**RE: Docket 4719 - 2017 Gas Cost Recovery Filing
Responses to Division Data Requests – Set 3**

_____)	
)	
Annual Gas Cost Recovery Filing)	Docket No. 4719
2017)	
)	
_____)

**MOTION OF THE NARRAGANSETT ELECTRIC
COMPANY D/B/A NATIONAL GRID FOR PROTECTIVE
TREATMENT OF CONFIDENTIAL INFORMATION**

Division 3-1

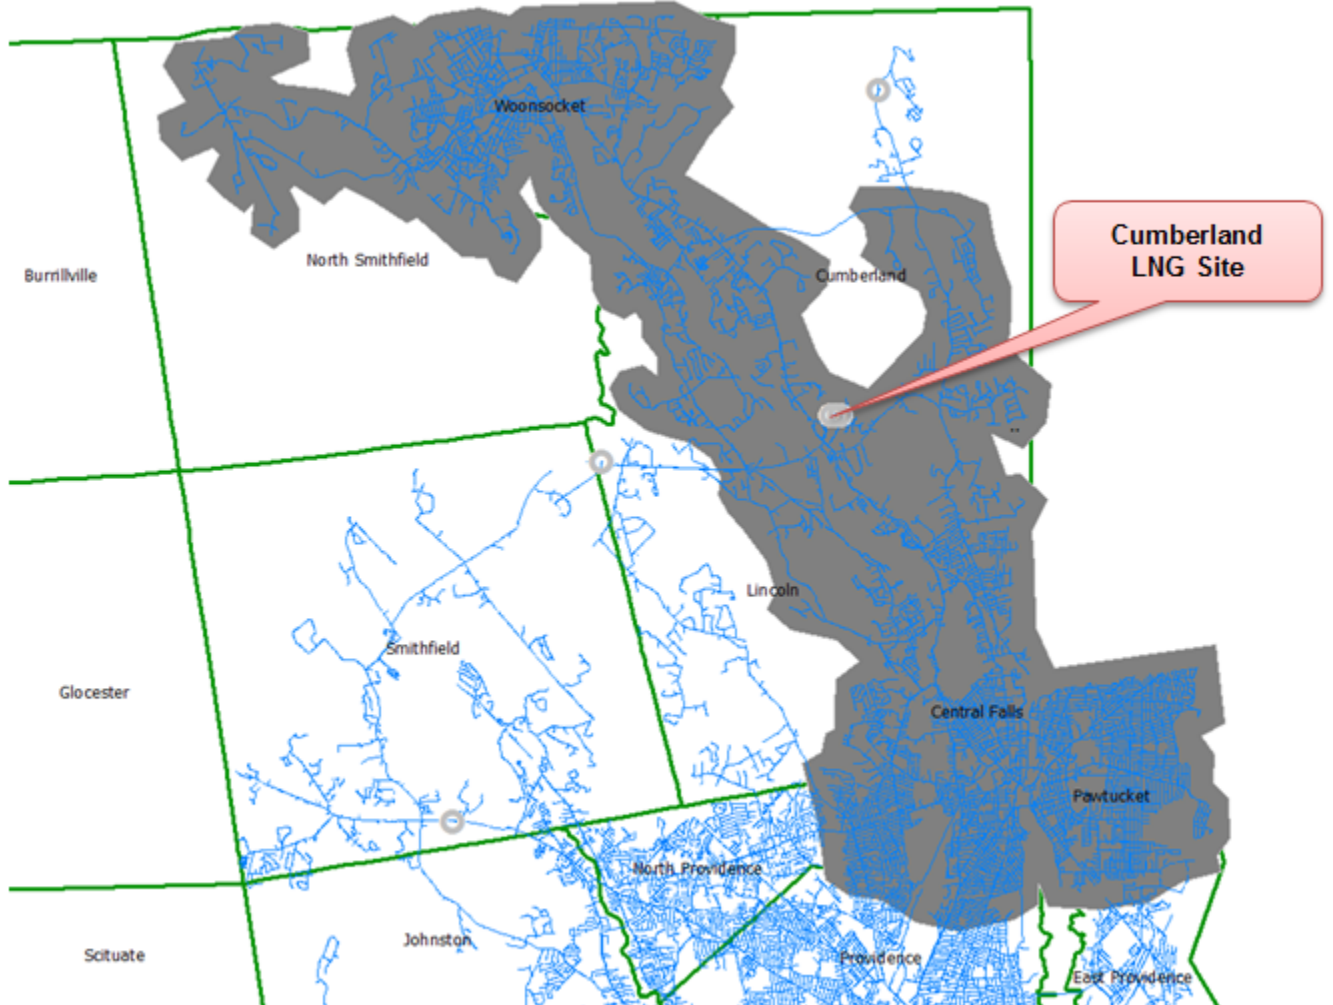
- a. Define and provide a map showing what is included in “*the area of the decommissioned Cumberland liquefied natural gas (LNG) site*,”
- b. Provide the data, analyses, and assumptions the Company has relied upon to assess its “*design day requirements in the area of the decommissioned Cumberland liquefied natural gas (LNG) site*” for:
 - i. The winter of 2017-2018
 - ii. For all other winter periods for which projections of design day requirements for the area of the decommissioned Cumberland LNG site.

- a. The map below shows the region of the Company's distribution system that was directly served by gas delivered to “the area of the decommissioned Cumberland liquefied natural gas (LNG) site”:

Attachment DIV 3-1-1

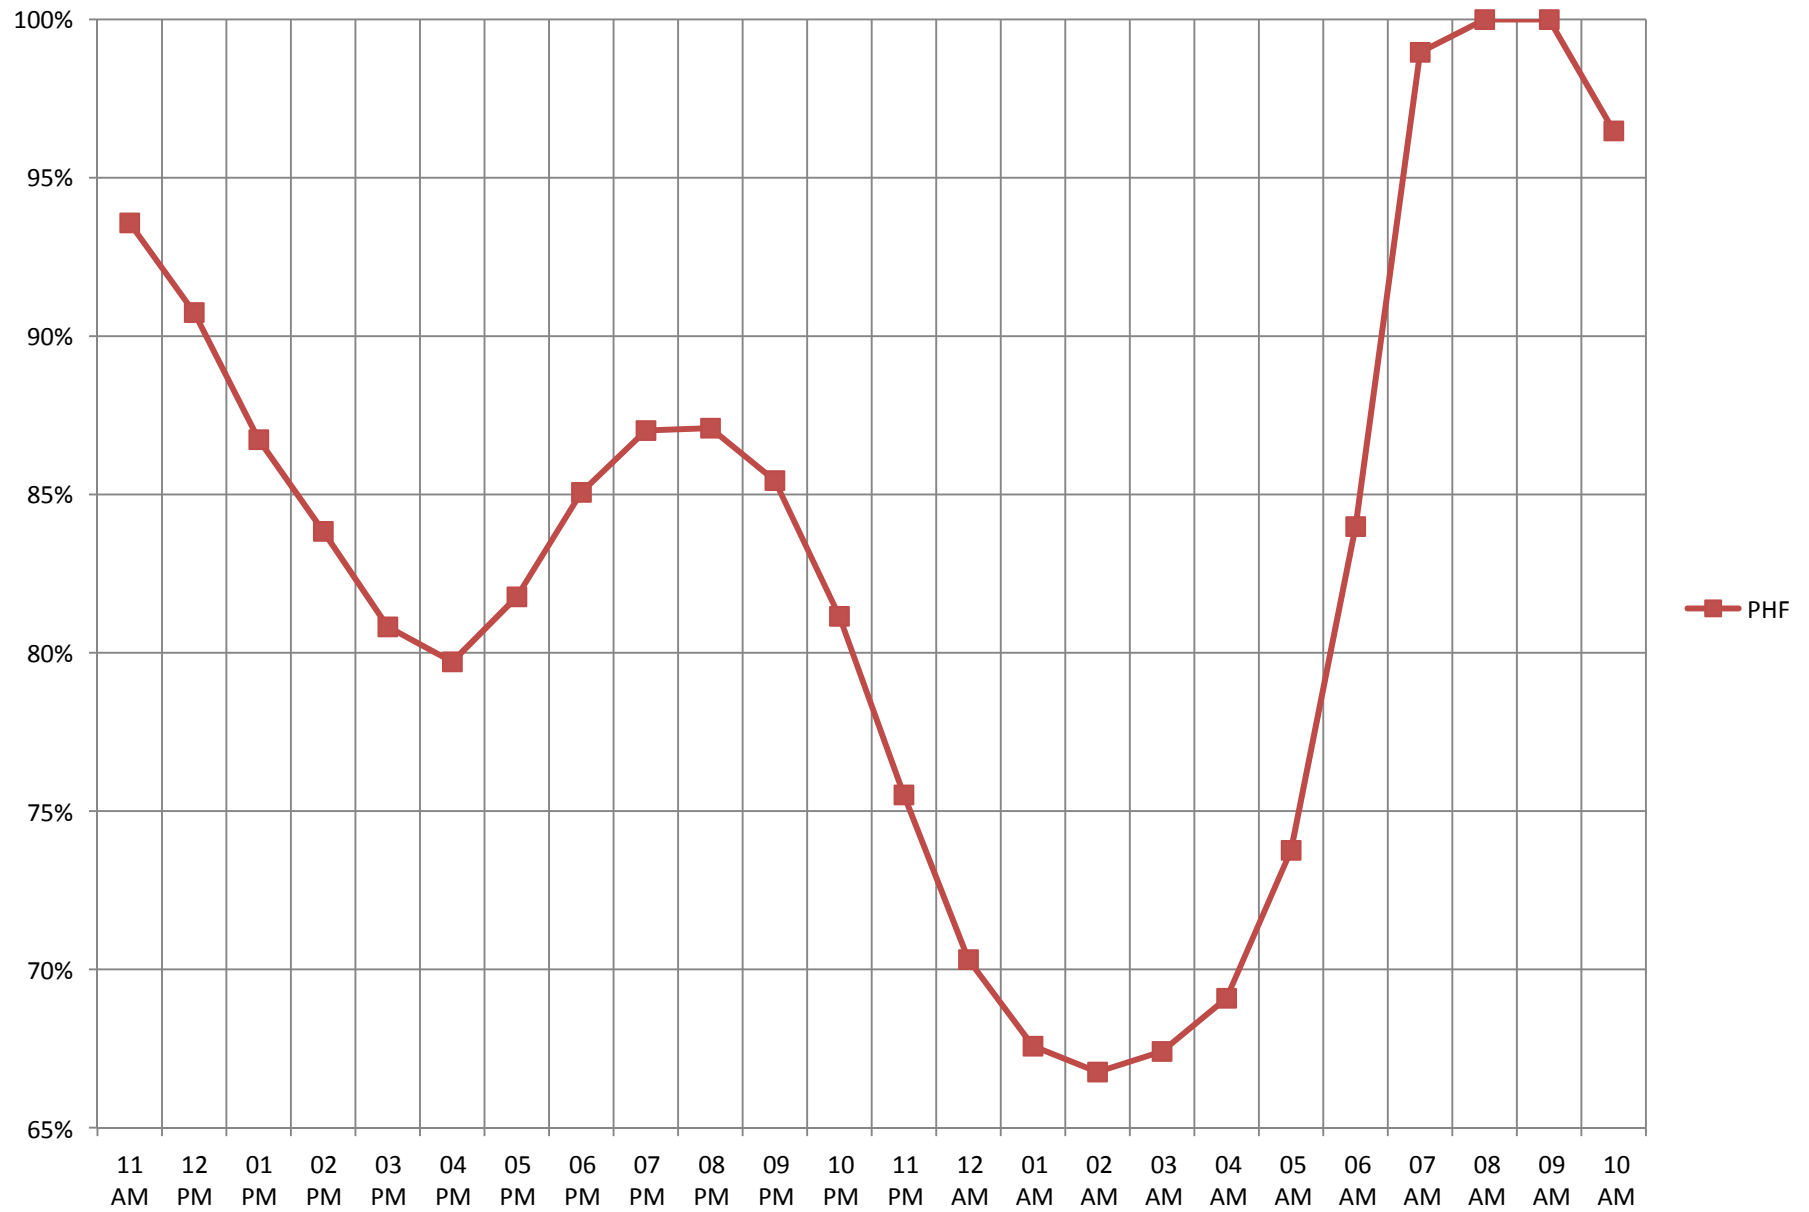
The hydraulic models are steady-state modeled as a 5% Peak Hour Factor. This is defined as the maximum hourly flow as a percentage of the total daily volume. In order to determine the need for volumes throughout the course of a day, historical data was evaluated to determine variability in flows. While variability occurs in the hourly flows as a percentage of the day, no significant correlation was found relative to Heating Degree Days (HDD). A plot of the percent of hourly flow by HDD is attached in Attachment DIV 3-1-1.

Attachment DIV 3-3-1

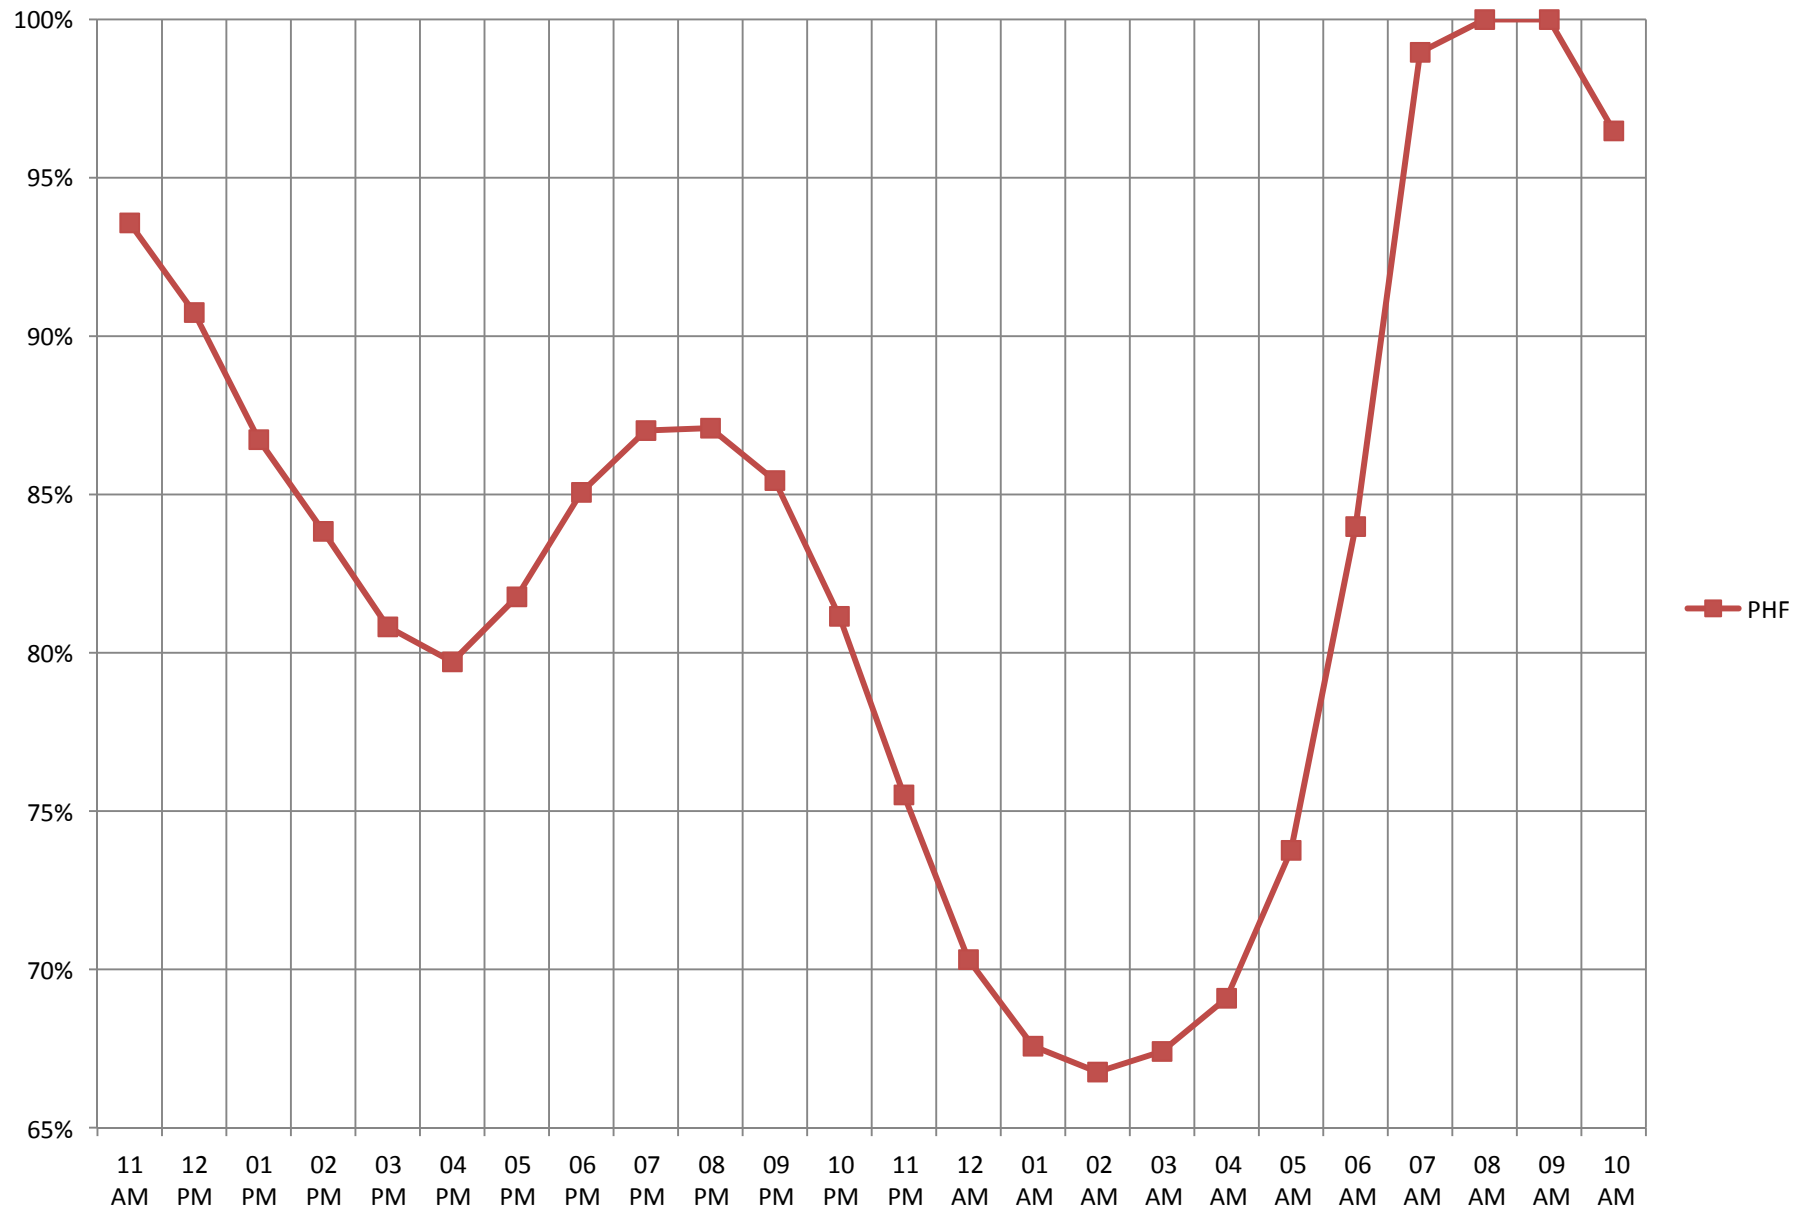
The hydraulic models are steady-state modeled as a 5% Peak Hour Factor. This is defined as the maximum hourly flow as a percentage of the total daily volume. In order to determine the need for volumes throughout the course of a day, historical data for the past two calendar years (2014 and 2015) was evaluated to determine variability in flows. While variability occurs in the hourly flows as a percentage of the day, no significant correlation was found relative to Heating Degree Days (HDD). A plot of the percent of hourly flow by HDD is attached in Attachment DIV 3-3-1.
